SUNDRY NOTICES AND REPORTS ON WELLS

8. Well Name and No.
UTAH 17/18 FED COM/825H

Mewbourne Oil Company requests approval to make the following change to the approved APD (30-015-56110):

Replace 20" surface casing with 20" conductor set at 200', as detailed in the attachment.

C-102 Submit Electronically Via OCD Permitting	State of New Mexico Energy, Minerals & Natural Resources Department OIL CONSERVATION DIVISION	Revised July 9, 2024 Submittal Type: X Initial Submittal / ☐ Amended Report / ☐ As Drilled

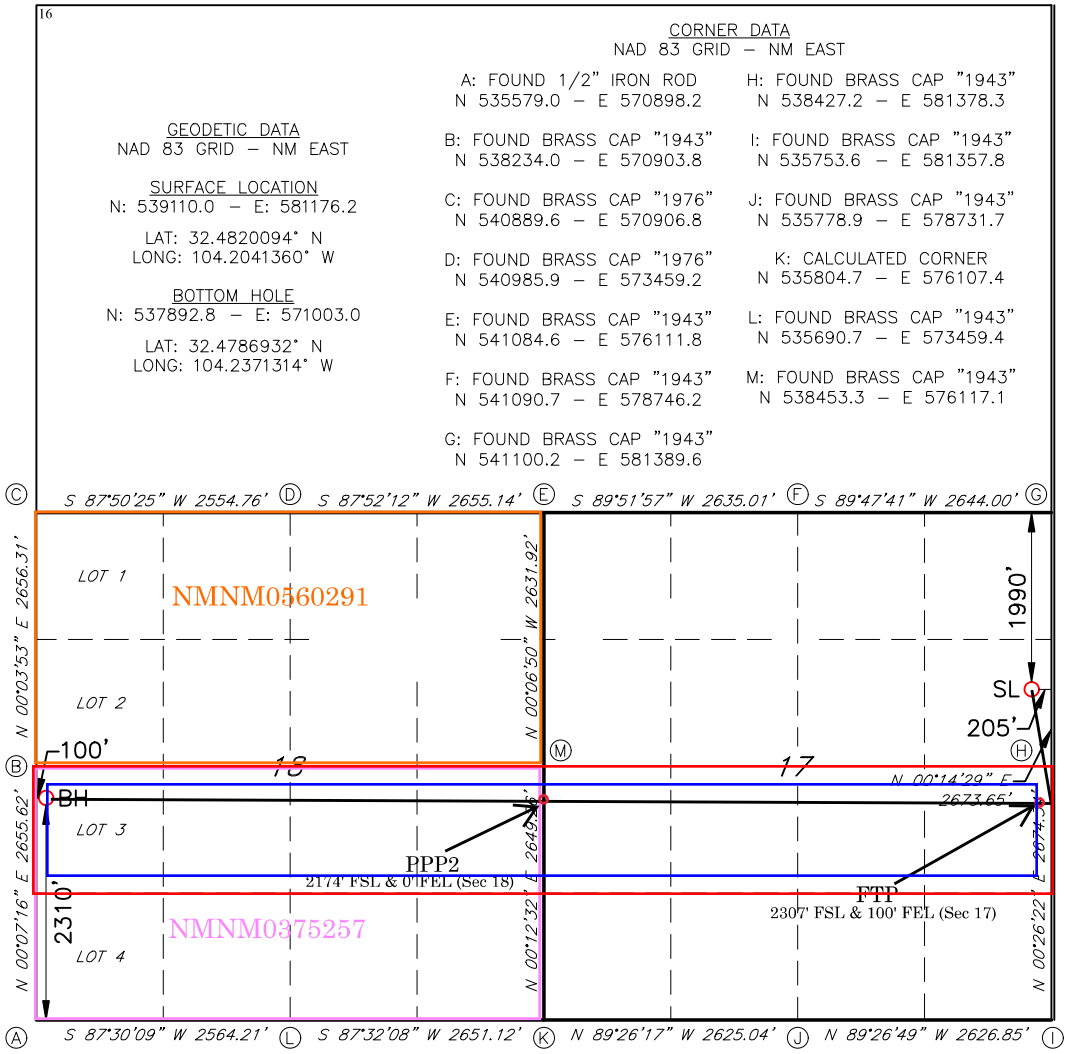
Change dedicated acreage from 640 acres to 317.21 acres.

Dedicated Acres	Infill or Defining Well	Defining Well API	Overlapping Spacing Unit (Y/N)	Consolidation Code
317.21	DEFINING
